Subject: Technical Revision 2, Nix Sand & Gravel Mine (M-2001-046), Response to Adequacy Review 1

RE: Technical Revision 2 Adequacy Review - Nix Mine (Permit M-2001-046), Weld County, Colorado

SUBJECT: Nix Site Groundwater Contamination Potential

Nix Monitoring Well Groundwater Elevations

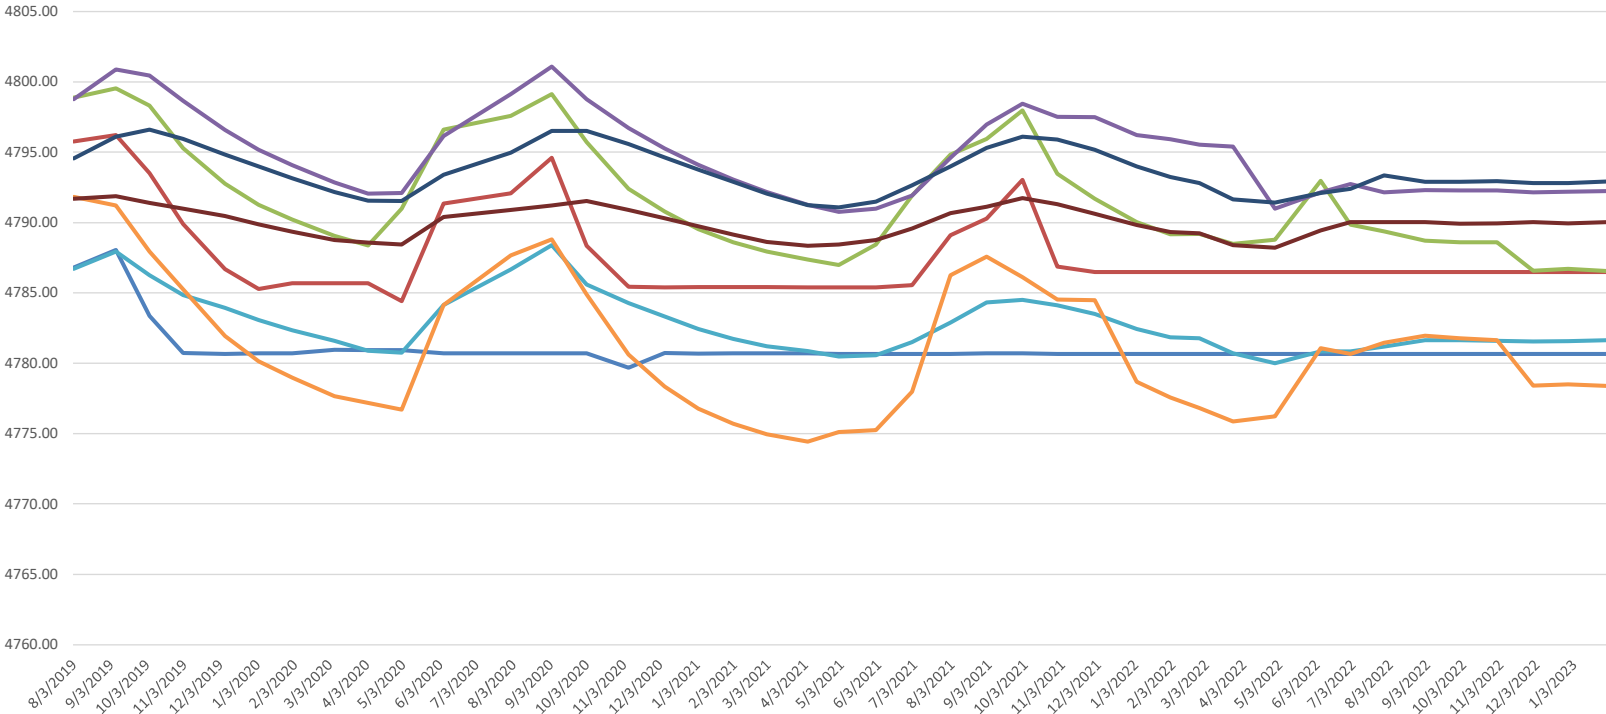
6. Graphic trendline data has been included.

Figure 1. Nix Site locations showing unlined areas, slurry walls, and cell configurations

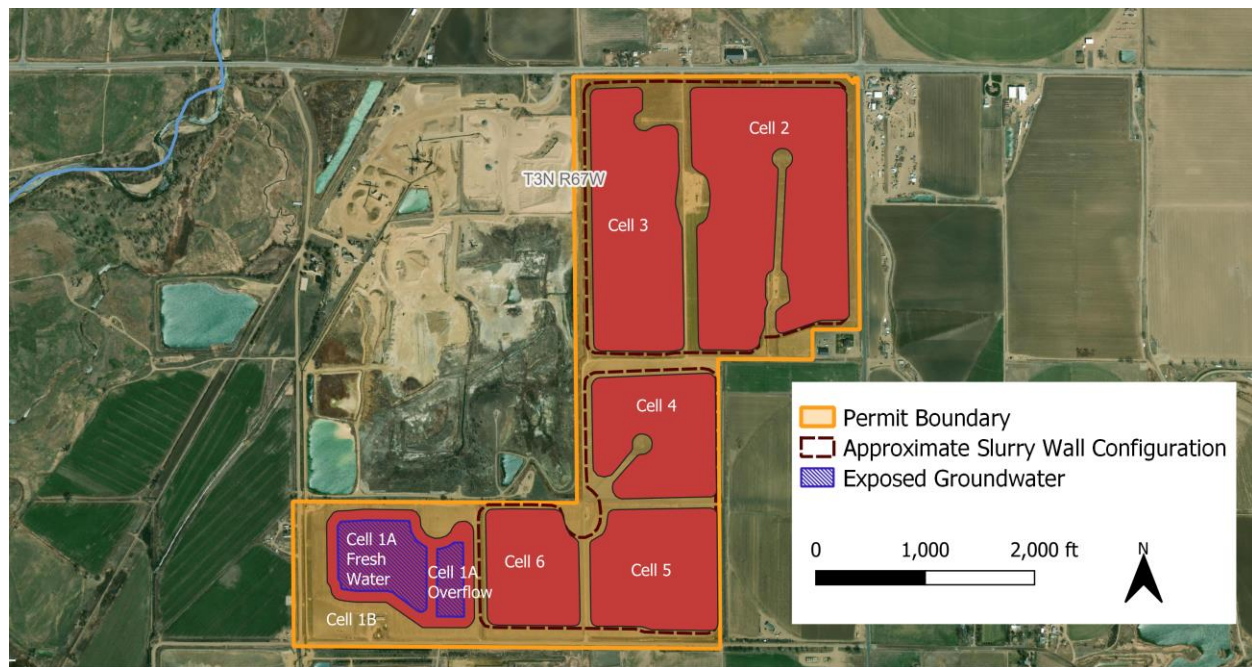
The Nix Site will contain unlined ponds, the freshwater and overflow ponds, in Cell 1 and the remaining cells will be effectively separated from the groundwater system by the installation of slurry walls prior to mining operations (**Figure 1**). The Nix Site is adjacent to several other sand and gravel mining operations that demonstrate the resource potential of the area and the lack of any significant known impacts or concerns regarding water quality in the area.

Cell 1A will be unlined and used to supply water to the concrete plant to be located in the area of Cell 6. Cells 2-6 will be surrounded by low permeability slurry walls prior to mining operations in those cells. The slurry walls will be keyed into the underlying low permeability bedrock to effectively hydrologically isolate the area from the surrounding groundwater. By virtue of the slurry walls and low permeability bedrock, the potential for groundwater contamination by operations in these areas is minute. This means that any significant potential for contamination to the groundwater system would be based on the potential for contamination at the unlined ponds in Cell 1.

Figure 3. Nix groundwater levels, wells, and adjacent mine sites

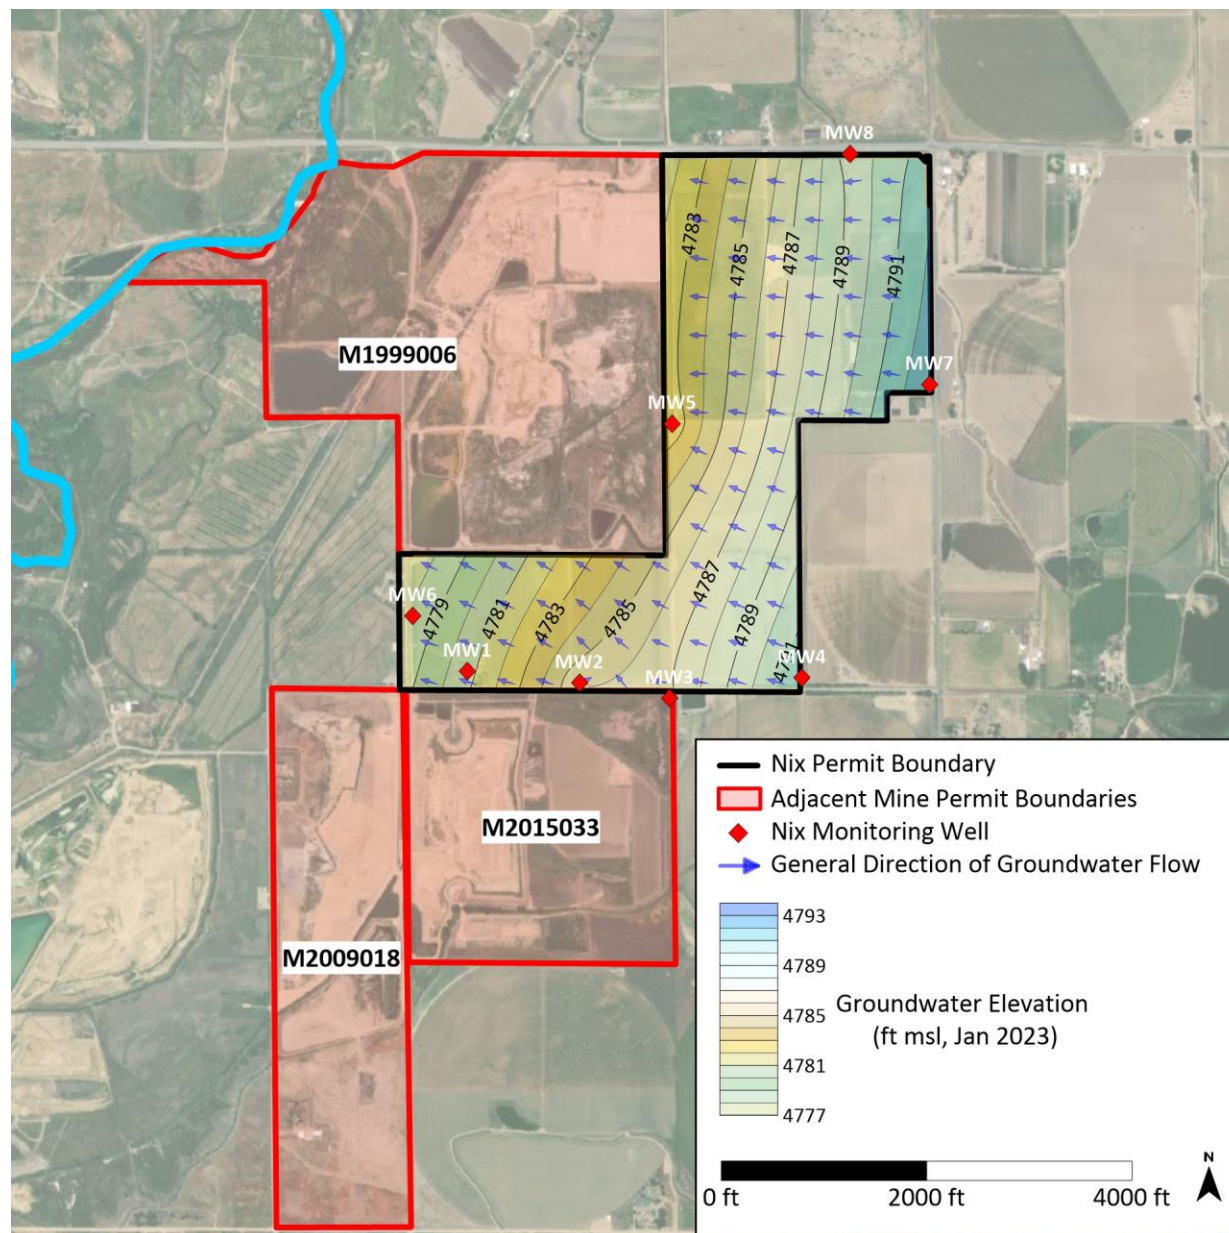
Based on RMCC’s monitoring data collected from eight monitoring wells (**Figure 3**) near the permit boundaries, the direction of groundwater flow in the area is generally to the west-northwest with an average groundwater gradient across the site of approximately 0.004 to 0.005. Using a hydraulic gradient of 0.0045 and a hydraulic conductivity of 350 ft/day based on aquifer data in the Colorado Division of Water Resources Decision Support System (CDSS), the groundwater flux through the permit boundary is about 325,000 ft³/day, which would act in-part to dilute any diffuse discharges of pollutants that could occur at the site. It should be noted that water levels in monitoring wells near the western and southern edges of the permit boundary are likely significantly affected by dewatering and/or cell lining occurring at the neighboring sites (DRMS Permit Nos. M1999-006 and M2015-033). Dewatering operations will make the water levels lower than the typical static water level absent the dewatering, while lining can tend to make water levels higher on the upgradient side of the liner. It seems apparent from data from Well MW5 that the depression in the water table from dewatering at the M2015-033 site coupled with the clay

The three adjacent mine sites operated by Raptor Materials LLC., DRMS Permit Nos. M1999-006, M2009-018 and M2015-033 (**Figure 3**), to our knowledge do not have permit requirements for monitoring groundwater quality and given the close proximity of these sites and the fact that they change the hydrologic regime of the area it does not seem that RMCC should be required to perform monitoring that is not required of the other sites. This is particularly true as dewatering and lining operations at the sites and at the Nix Site have the potential to change the groundwater flow paths such that any potential contaminants

Figure 4. Groundwater wells located in the vicinity of the Nix Site

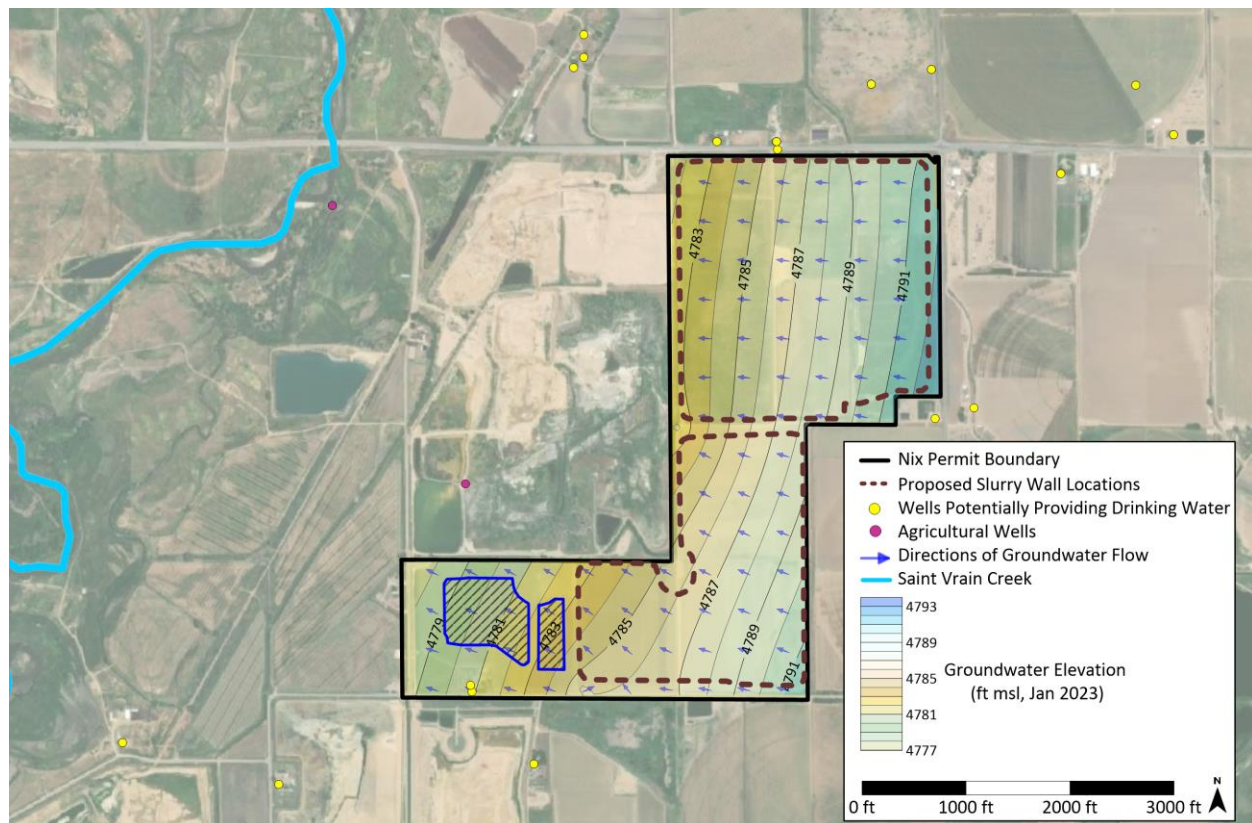
If contaminants were somehow introduced into Cell 1 it is unlikely they would be introduced in sufficient volumes to cause a potential threat to the public health, safety, or welfare, particularly given the lack of domestic, municipal, or agricultural use of the groundwater downgradient of the Nix Site. Utilizing the GIS database of well permits provided through CDSS, we looked at wells located in the vicinity of the Nix Site. For wells that potentially provide drinking water, we looked at wells with permitted uses including household use only, domestic, commercial, or municipal. For agricultural wells, we looked at wells with permitted uses of stock or irrigation. **Figure 4** shows that there are no wells that potentially provide drinking water located downgradient of either the unlined pond areas or the proposed slurry walls. While **Figure 4** does show two agricultural wells downgradient, one well, located in the permit boundary of an adjacent mine site, is no longer used for irrigation and the other is a small stock watering well that is nearer to Saint Vrain Creek and relatively far downgradient of the Nix site. This stock watering well is also within the permit boundary of the M1999-006 site, although it does appear that the area is yet to be mined and any potential contamination from the Nix Site would be heavily diluted prior to reaching this well. The unlined portions of the M1999-006 mine site, which has no monitoring requirements, would have a significantly higher risk of impacting this well than would the Nix Site and the M2015-033 site would present similar concerns but also has no monitoring requirements. Additionally, because most of the area downgradient of the Nix Site is covered by current and future gravel pits or is within the floodplain of Saint Vrain Creek, future development of the groundwater in the area is likely to be limited.
